ENGINE 112, 113 in MODEL 163.1## ## up to 357786
 ENGINE 112 in MODEL 202.02
 ENGINE 112 in MODEL 202.08
 ENGINE 112 in MODEL 210.06
 ENGINE 113 in MODEL 210.07
 ENGINE 112 in MODEL 210.663
 ENGINE 112 in MODEL 210.26# ## up to 276396
 ENGINE 113 in MODEL 210.27# ## up to 276396
 ENGINE 112, 113 in MODEL 210.08# ## up to 084039
 ENGINE 112, 113 in MODEL 210.28# ## up to 084039

Category	Op. no.	Operation text	Time	Acc. no.	Code
P	023813	Remove/install/replace gasket between intake pipe and throttle valve	006 WU/0.5 h	---	---

P07.07-2038-01

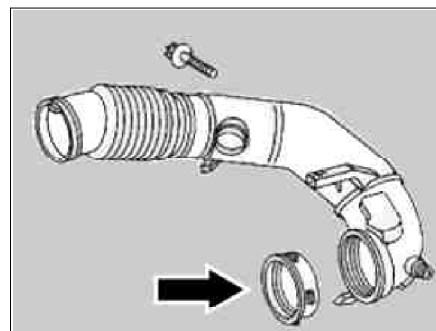
Damage code	Cause	Remedy	
14 034 04	Gasket (B) between intake pipe (A) and throttle valve defective. <i>i</i> High oil consumption of more than 0.8 liters per 1000 km.	<i>i</i> In order to avoid erroneous removal the following documents must be processed before starting the work: # High oil consumption Measure oil consumption	AF18.00-P-8044D AR18.00-P-0025AV
		1 Remove,/install/replace gasket (B) between intake pipe (A) and throttle valve.	AR07.07-P-1454A
		<i>i</i> Use new gasket according to parts ordering notes Old gasket with part number 112 141 01 80 should no longer be used.

Part no.	Designation	Quantity
A 112 141 18 80	Gasket	1
